APPLICATION NO.	FILING DATE	FIRST NAMED INVENTOR	ATTORNEY DOCKET NO.	CONFIRMATION NO.
09/516,731	03/01/2000	Mitsuru Nishitsuka	041514-5171	2693
629 · 75	90 10/04/2002			
ERNEST PETER JOHNSON			EXAMINER	
PARLEE MCLA 1500 MANULI	FE		RODRIGUEZ, ARMANDO	
	10180- 101 STREET			PAPER NUMBER
CANADA			2828	
			DATE MAILED: 10/04/2002

Application No.	Applicant(s)	
5	09/516,731	NISHITSUKA ET AL.	
Office Action Summary	Examiner	Art Unit	
	Armando Rodriguez	2828	
The MAILING DATE of this communication appeared for Reply	opears on the cover sheet with	the correspondence address	
A SHORTENED STATUTORY PERIOD FOR REPI THE MAILING DATE OF THIS COMMUNICATION  - Extensions of time may be available under the provisions of 37 CFR 1 after SIX (6) MONTHS from the mailing date of this communication.  - If the period for reply specified above is less than thirty (30) days, a re  - If NO period for reply is specified above, the maximum statutory period  - Failure to reply within the set or extended period for reply will, by statu  - Any reply received by the Office later than three months after the maili earned patent term adjustment. See 37 CFR 1.704(b).	136(a). In no event, however, may a repleptly withi

FIG. 2

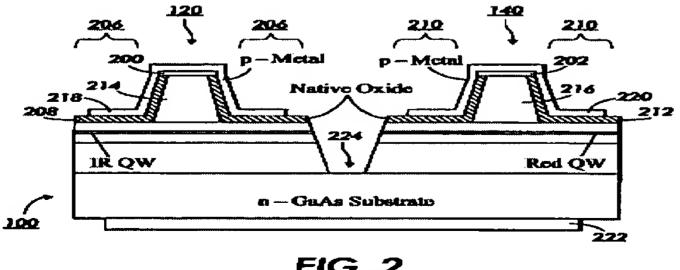
Figure 2 illustrates a semiconductor laser having two laser units with a ridge structure on opposite sides of the isolation groove (224). The semiconductor laser structure having an n-type layer, an active layer and a p-type layer with p and n electrodes, where the p and n electrodes of the laser units being electrically connected.

Figure 2 Sun et al illustrates a semiconductor laser having two laser units with a ridge structure on opposite sides of the isolation groove (224). The semiconductor laser structure having an n-type layer, an active layer and a p-type layer with p and n electrodes, where the p and n electrodes of the laser units being electrically connected.

Sun et al does not disclose providing a Schottky barrier within the electrodes.
